41 E. Main Street Tree Preservation Plan – TREE-13098

Tom Kiepura, City Arborist ISA #OH-6684A *TMK*

City of Hudson

TREE PRESERVATION PLAN

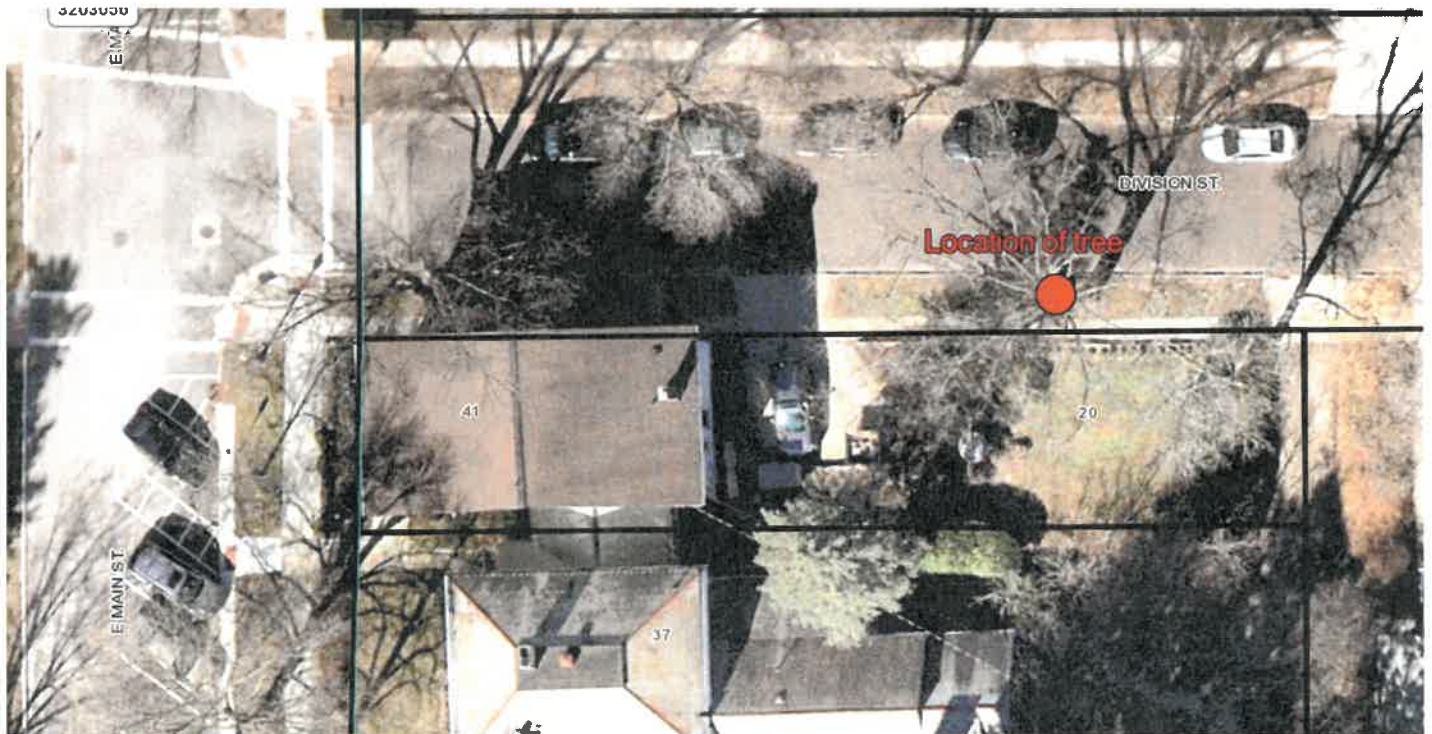
The proposed construction, according to the revised plans submitted to the Arborist, would require excavation and removal of topsoil within the limits of the calculated TPZ. Specifically, a trench would be dug for the footer for the proposed building, and topsoil removed for the installation of a paver patio. It should be noted that most of the fine roots that provide water and nutrient uptake exist in the uppermost soil profile and will be removed along with the topsoil. It is presumed that this excavation would then be backfilled with a limestone base. The proposed patio is approximately 135 square feet.

I propose that at the limits of disturbance, prior to construction, any roots that are to be cut shall be exposed with an air spade and cut cleanly with a saw. This root pruning should take place

I also propose a tree protection barrier be installed prior to any construction activity. This barrier (a fence) excludes access to areas within the calculated tree protection zone that are outside of the limits of disturbance. **There shall be no soil cuts or fills, or otherwise change of grade within this tree protection barrier. No construction activities, staging, storage, or otherwise utilization of this space shall occur for the duration of project. This includes trucks, heavy equipment, and construction materials. The deep root fertilization, root invigoration, root pruning, and installation of the tree protection barrier shall be subject to inspection by the City Arborist.**
